AUDIT SUMMARY REGARDING THE LICENSE RENEWAL APPLICATION FOR THE SHEARON HARRIS NUCLEAR POWER PLANT, UNIT 1

By letter dated November 14, 2006 (ML0633502670), Carolina Power & Light Company, doing business as Progress Energy Carolinas, Inc., submitted, for the U.S. Nuclear Regulatory Commission's (NRC) review, an application to renew the operating license for the Shearon Harris Nuclear Power Plant (HNP) Unit 1 for an additional 20-year period beyond the end of the current license term of FOL NPF-63. The end of the current license term is October 24, 2026. The license renewal application (LRA) was submitted pursuant to Title 10 of the Code of Federal Regulations Part 54 (10 CFR Part 54), "Requirements for Renewal of Operating Licenses for Nuclear Power Plants."

VI. STAFF'S AUDIT QUESTIONS AND APPLICANT'S RESPONSES

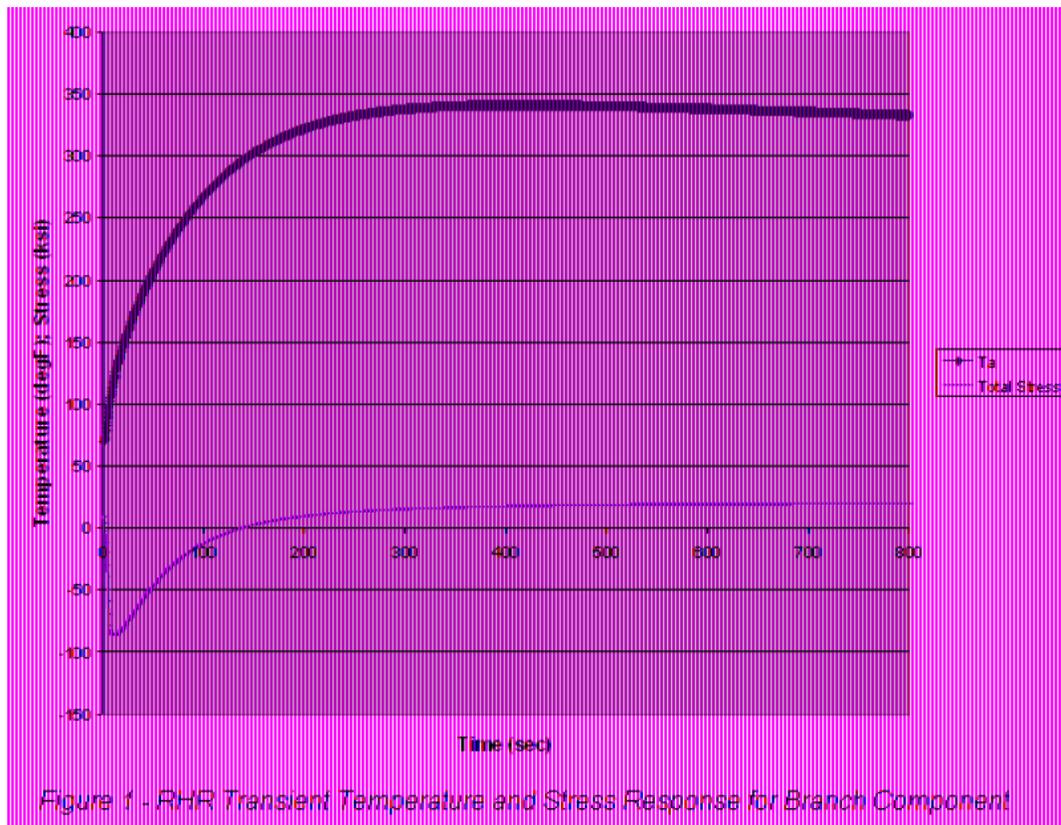
To address the question regarding the effect of the pressure and moment stresses on the total stress and resulting Fen, a detailed time history of the stress during the full RHR transient cycle was developed for the 12" x 1" branch component. The stresses were calculated consistent with the HNP design basis inputs and NB-3600 evaluation methodology. Applicable thermal transient, moment, and pressure histories were applied representing the RHR system design transient in the section of the RHR line containing the branch connection. The transient temperature goes from ambient conditions, at 70°F, to 350°F simulating the initiation of RHR flow through the otherwise isolated section of piping. The design transient description also assumes after the transient that gradual cooling of the system occurs at 100°F/hr, which was considered to represent negligible stress in the design. The RHR flow is initiated by design at approximately 425 psig system pressure. Therefore, a pressure load of 450 psia was used in the calculation. The moment stress from the piping design analysis of the branch was realistically ramped over the transient as a function of the pipe temperature. Pressure and moment stresses were considered only as tensile. The thermal stresses were appropriately signed to represent the inside wall stress in response to the thermal transient. The stresses were adjusted with the branch stress indices

consistent with the Code analysis. The resulting stress history is illustrated in Figure 1 on the next page.

This demonstrates that for the significant part of the transient history, the component is in the compressive state on the inside surface where environmental effects may be applicable. For this reason, in the initial estimation of environmental effects on this component, it was judged that environmental effect would be small and $F_{en} = 1.0$ was applied. However, the time history shown does include some periods where stress is in the tensile regime due to the pressure and moment
